## Product Change Notification / SYST-31XXGV266

ERRATA - PIC18F04/05/14/15Q40 Silicon Errata and Data Sheet Clarifications Silicon Die Revision Addition

1) Adding silicon revision D3.

## PIC18F04/05/14/15Q40 Silicon Errata and Data Sheet Clarifications

### 1.4.1 UART TXDE Signal May go Low Before The STOP Bit Has Been Entirely Transmitted.

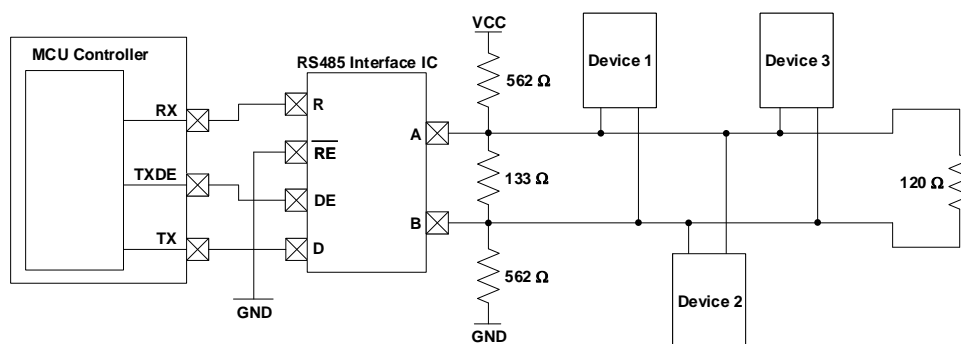
The UART Transmit Drive Enable (TXDE) signal could potentially transition into a low state before the UART STOP bit has been entirely transmitted due to the effects of parasitic capacitance on the TX line. In some applications, this could result in communication being prematurely terminated due to the TXDE bit going low before the STOP bit has had enough time to settle.

In order to ensure that the STOP bit settles into its final logic state before the TXDE signal transitions low, a biasing circuit can be implemented. A biasing circuit allows the TX line to either be driven high or low, rather than being left in a floating tri-state mode where prolonged rise or fall times could lead to communication being disrupted. This bias circuit should only be implemented on one end of the serial bus, and a termination resistor should be used on the other end. The figure below show an example of a bias circuit that can be used to achieve this.

Please note that the resistor values used in this circuit are recommendations, and that the actual resistor values required may vary based on the application.
